MANANTALI DAM

NOTE N° 27
Rev. A.

REPORT ON THE DAMAGE
TO THE RIP-RAP

DEFINITION OF THE WORKS
EXECUTION MODE AND SCHEDULE
COST ESTIMATE

SOLUTION 4

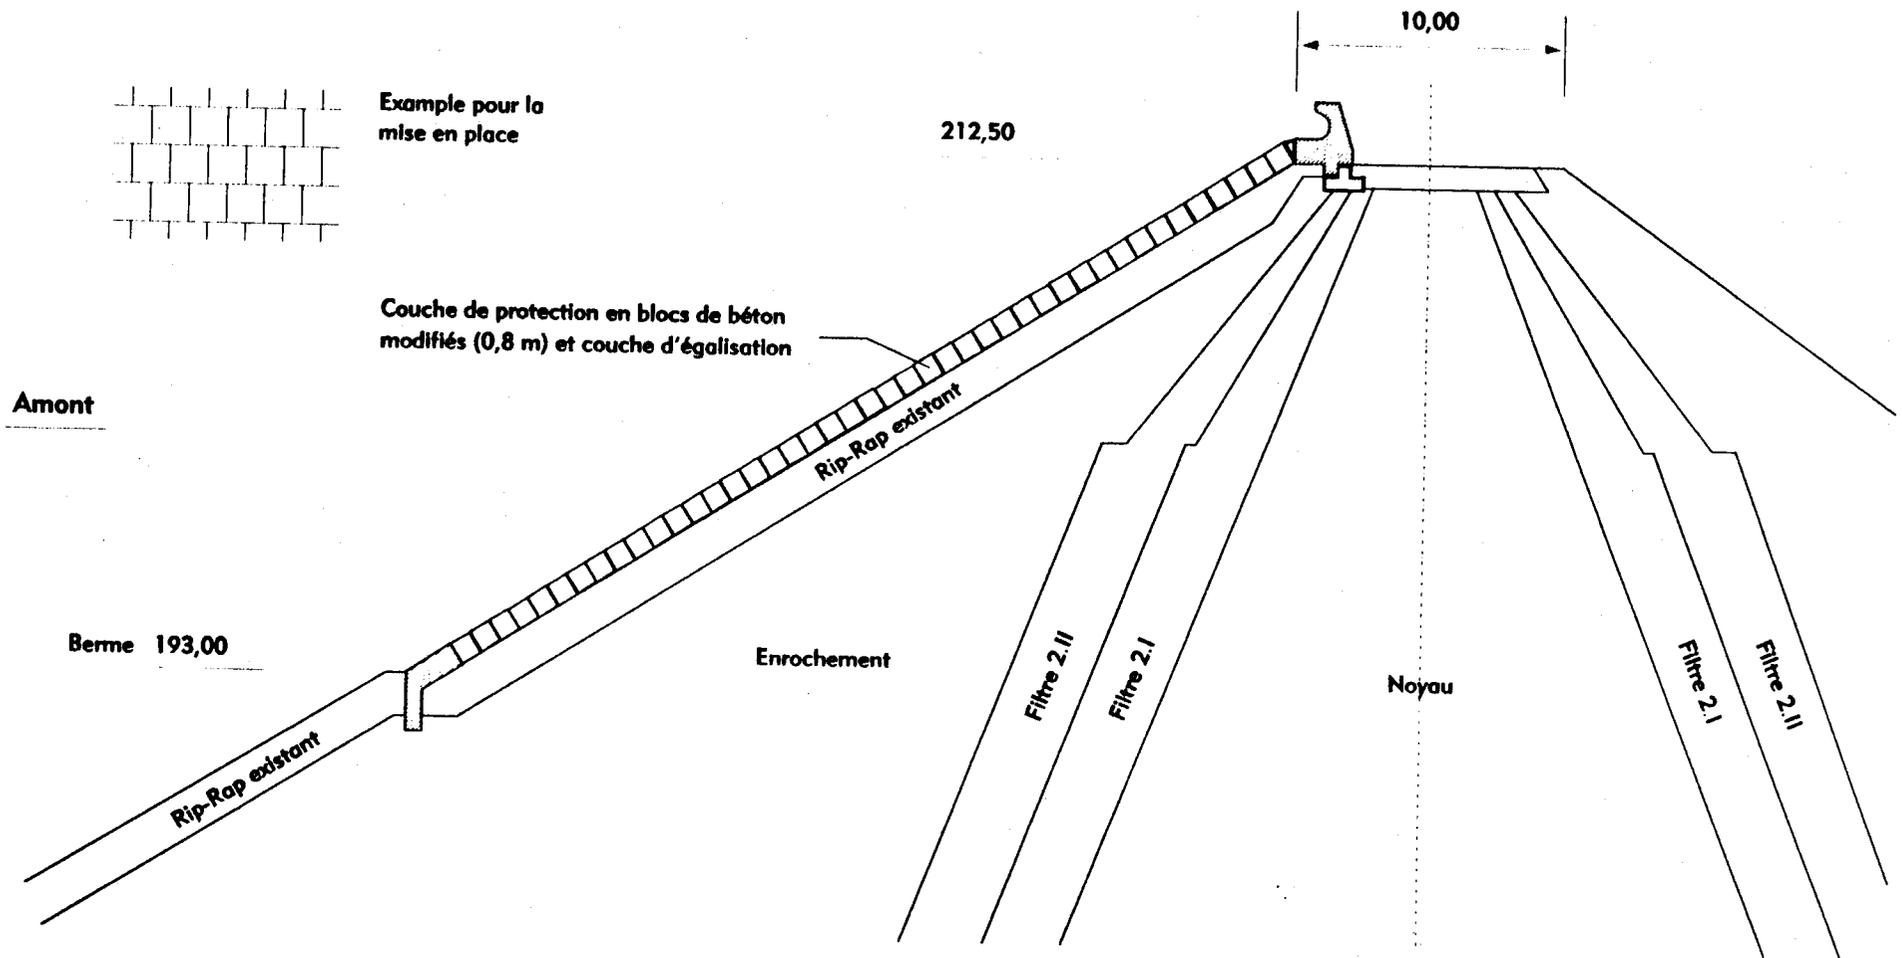
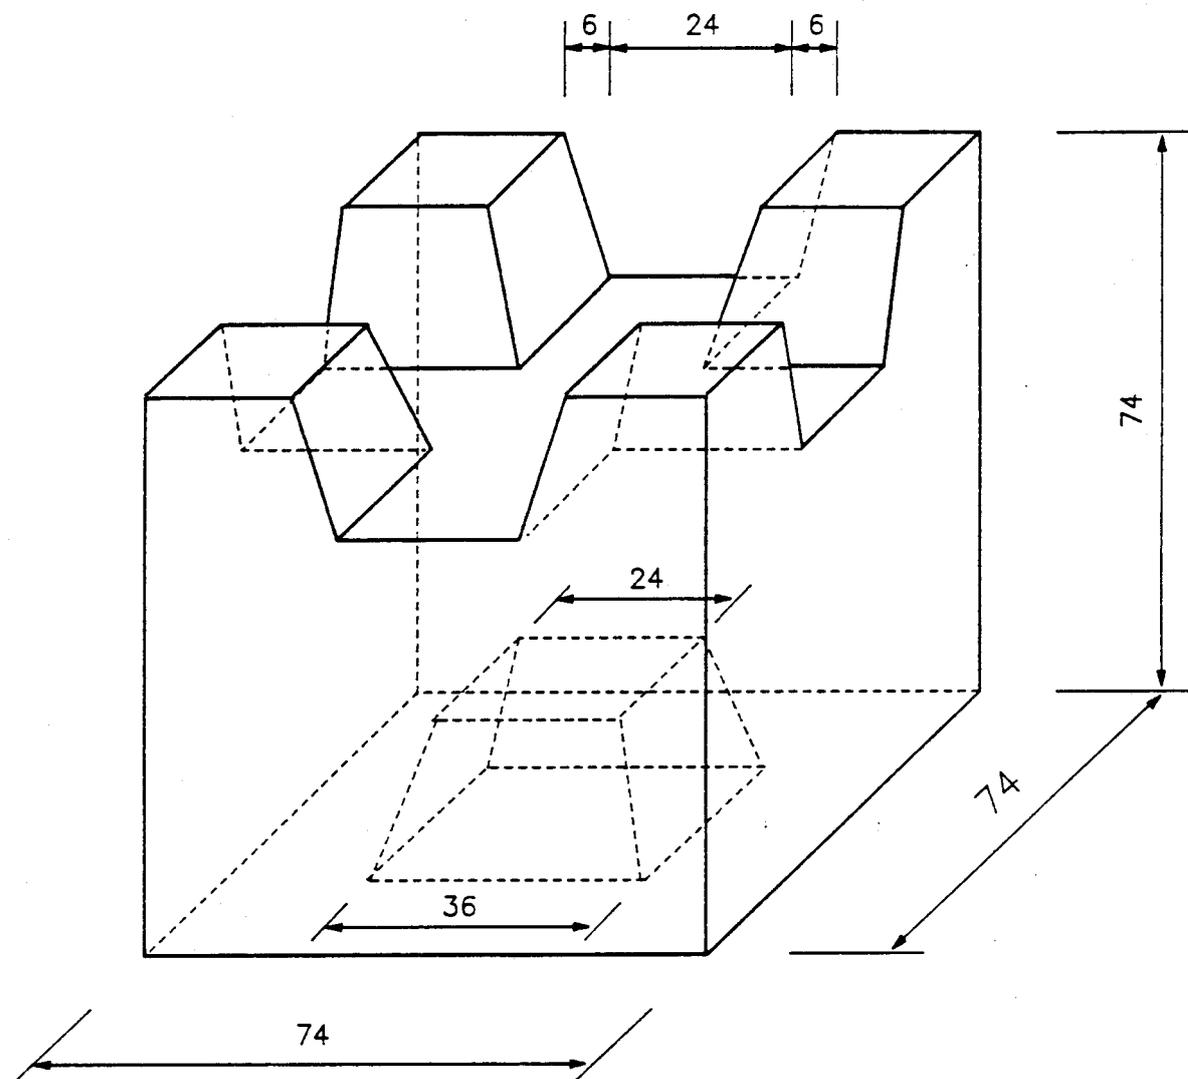
Solution 4 - Concrete blocks of special shape

This "non rip-rap" solution consists of positioning concrete blocks of a special shape on the existing rip-rap after the surface of the latter is suitably equalised. The blocks are made on site so as to leave open joints between blocks and interlocked in a similar way to brick walls, that is to say that the joints perpendicular to the embankment's axis would be interrupted by the next block.

As in solution 3, this alternative calls for no removal of the existing rip-rap, the support along the 193 m level berm being provided by a concrete block anchored in the protective rockfill.

However, as in solution 3, it is feared that local damage would propagate quickly and provoke the partial ruin of the protection.

In such a case, repairs would become extremely difficult. This solution cannot be recommended.

SOLUTION 5

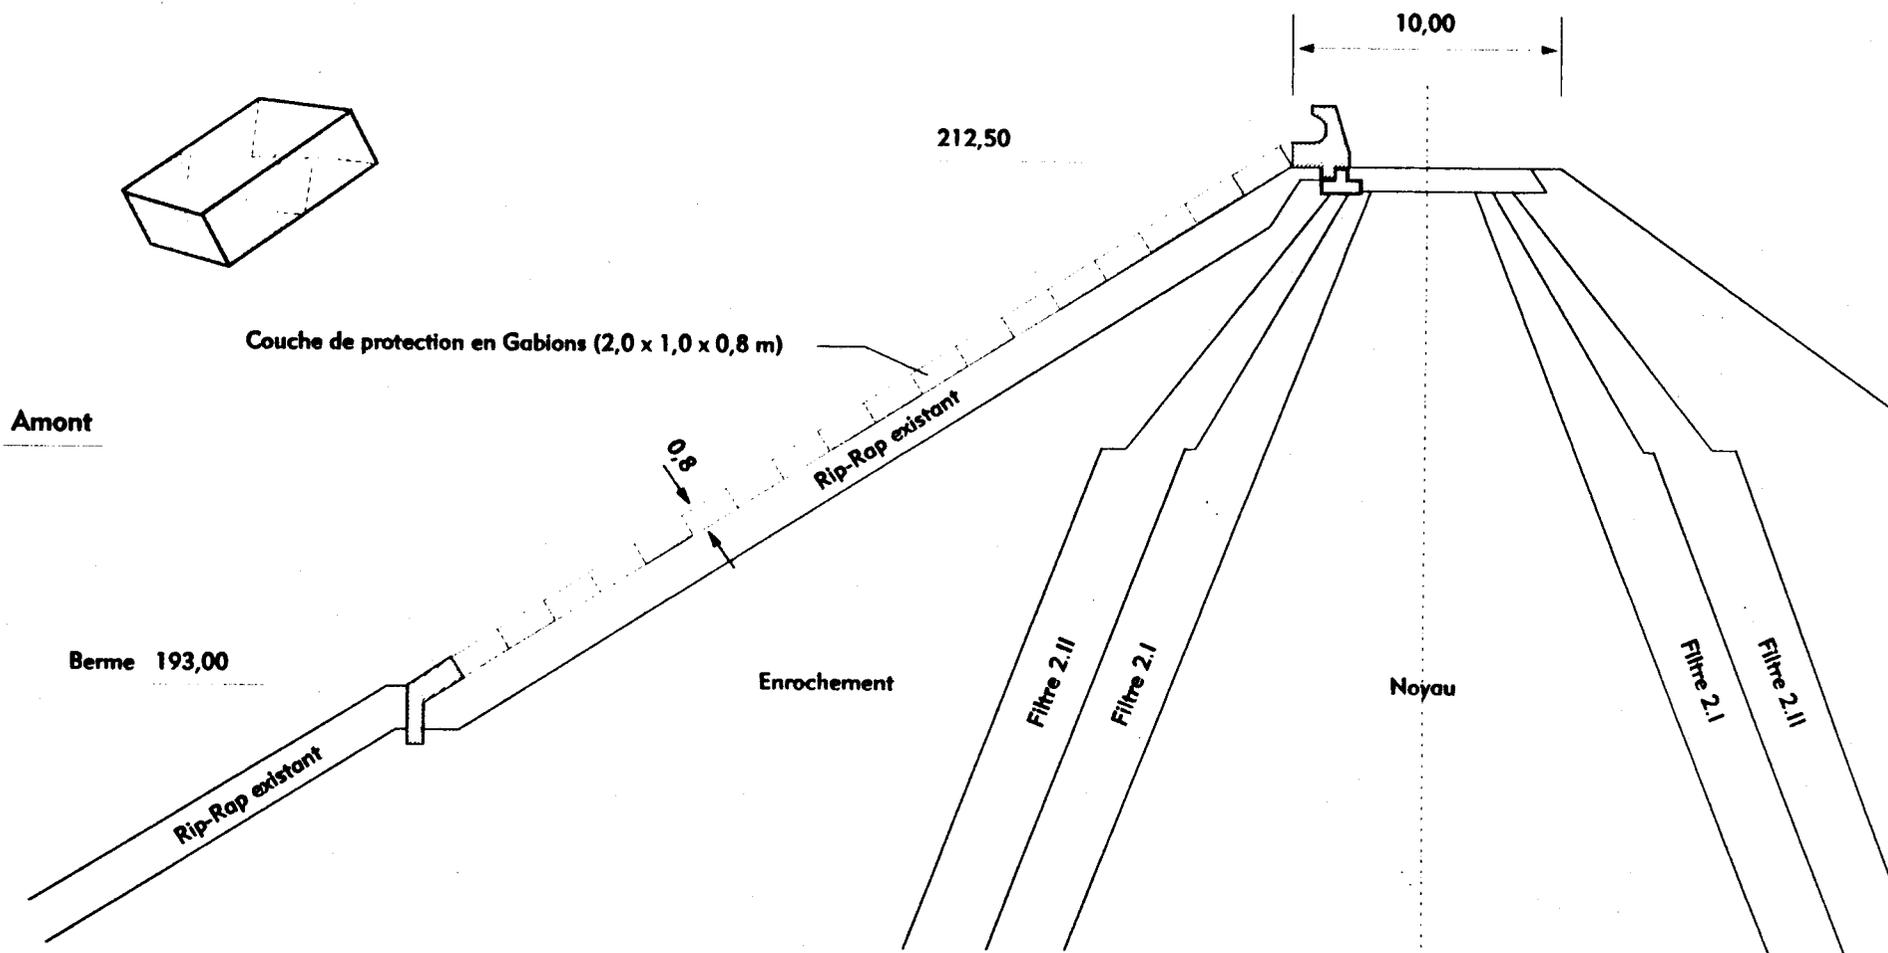
Solution 5 - Gabions

This "non rip-rap" solution consists in positioning gabions 1 m thick, 1 m wide and 2 m long on the equalised surface of the existing rip-rap.

This solution no longer depends on the solidity of individual elements but ensures solidity through the anchoring or confinement of a large mass of relatively small rocks held in a steel wire cage.

The solidity of the whole will mainly depend on the proper construction of the gabions, on their good internal tightening as well as on the proper positioning of the rocks within the gabion.

The good resistance of a rip-rap calls for as high a percentage of voids as possible. This requirement runs counter to the necessity of constructing a very solid and highly compact gabion.

Another specific disadvantage of this solution is that the gabions' wire will be highly prized by the local population and runs the risk of disappearing little by little.

This solution is discarded for the reasons given above.

SOLUTION 6

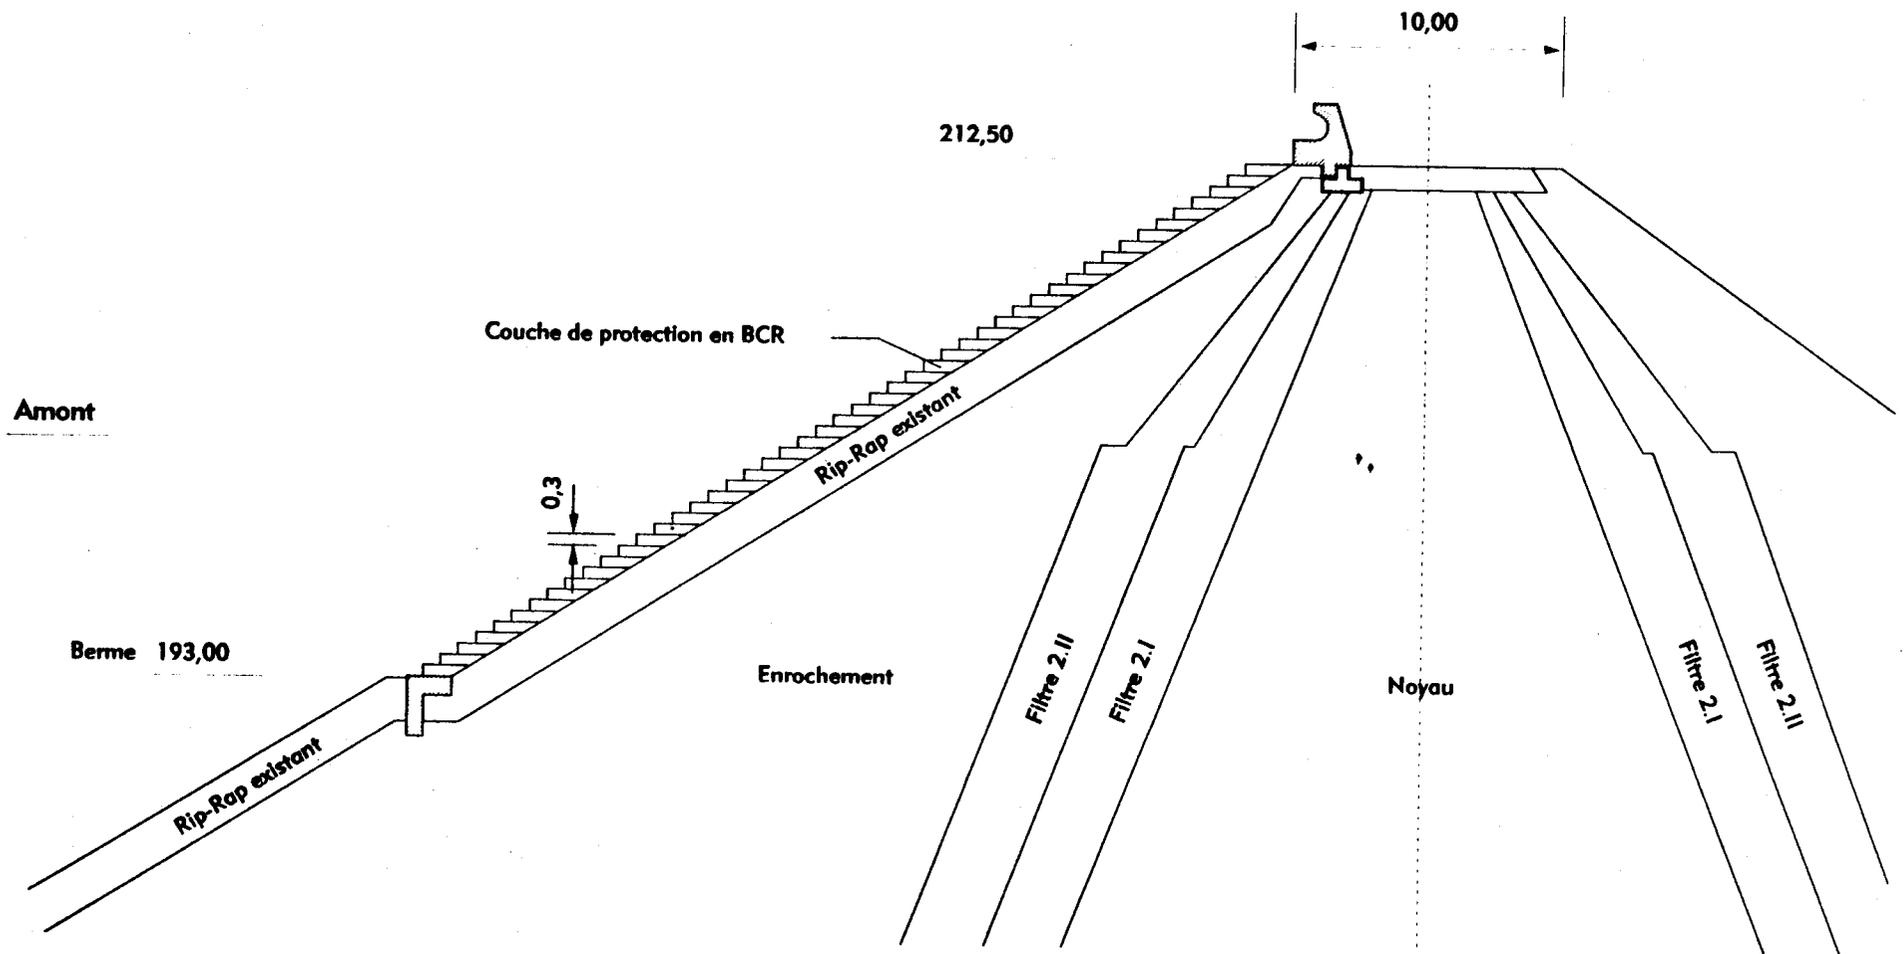
Solution 6 - Roller-compacted concrete (BCR)

This solution is the furthest away from the concept of a flexible rip-rap protective layer. It consists in laying horizontal concrete strips on the existing rip-rap and to compact them in succession in the same way as the steps of a stairway. Surface compacting would produce too smooth a surface.

This solution is technically feasible but would give rise to permeability and drainage problems. Moreover,, this solution would constitute a rigid element over a flexible backfill, which could subsequently set problems of differential settling.

This solution is discarded.
